FNP NFPA 805 LAR AUDIT

March 20, 2013

Session 2 – LAR and LIC 109 Sensitivity Studies

CDFs and Δ CDFs relative LAR Base case values

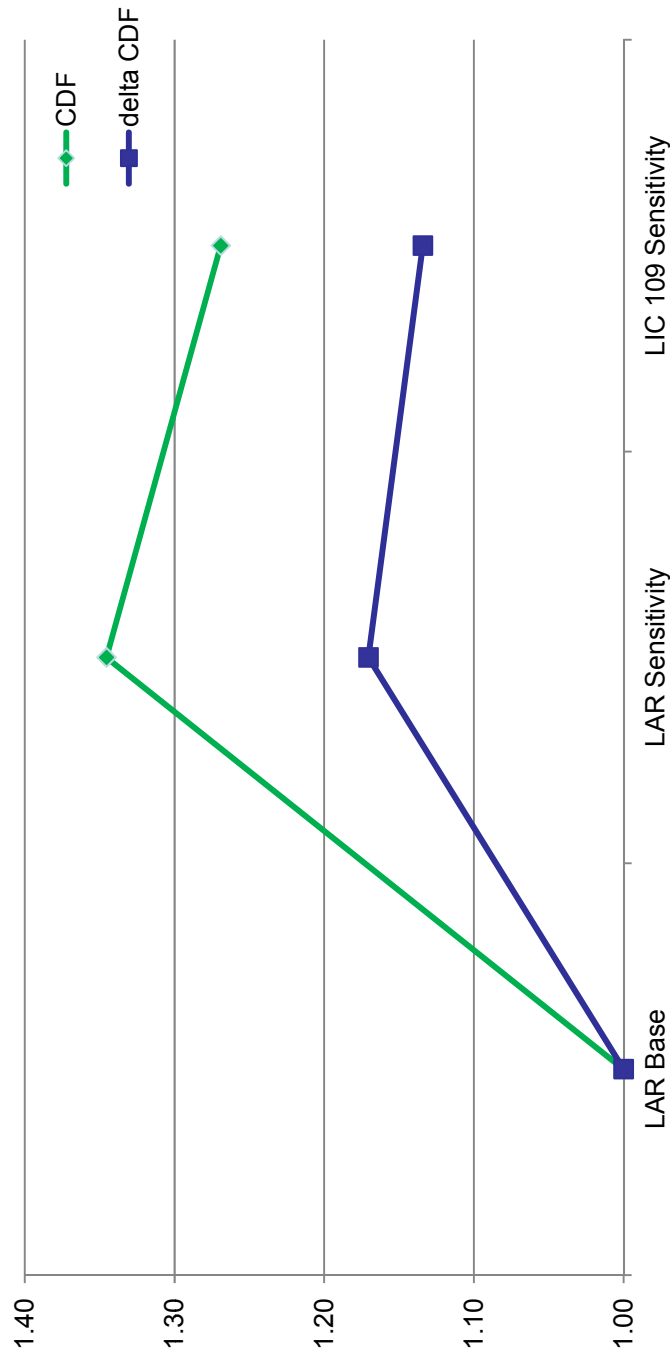
In Enclosure 6 to the supplement dated December 20, 2012(Agency wide Document Access and Management System Accession Number ML 12359A050), both the total and delta core damage frequency (CDF) results are actually lower than previously reported in the September 25, 2012 submittal, when only the credit for the electrical cabinet factor was removed. With the additional removal of credit for the main control room (MCR) very early warning fire detection system (VEWFDS), it is expected that these CDF results would increase, consistent with the increases in the large early release frequency (LERF) values.

Provide an explanation of the reasons for the divergent results, including the key modeling assumptions that are causing the divergence.

(note) Graph is based on as reported values in the LAR and in the Response to LIC 109 RAIs
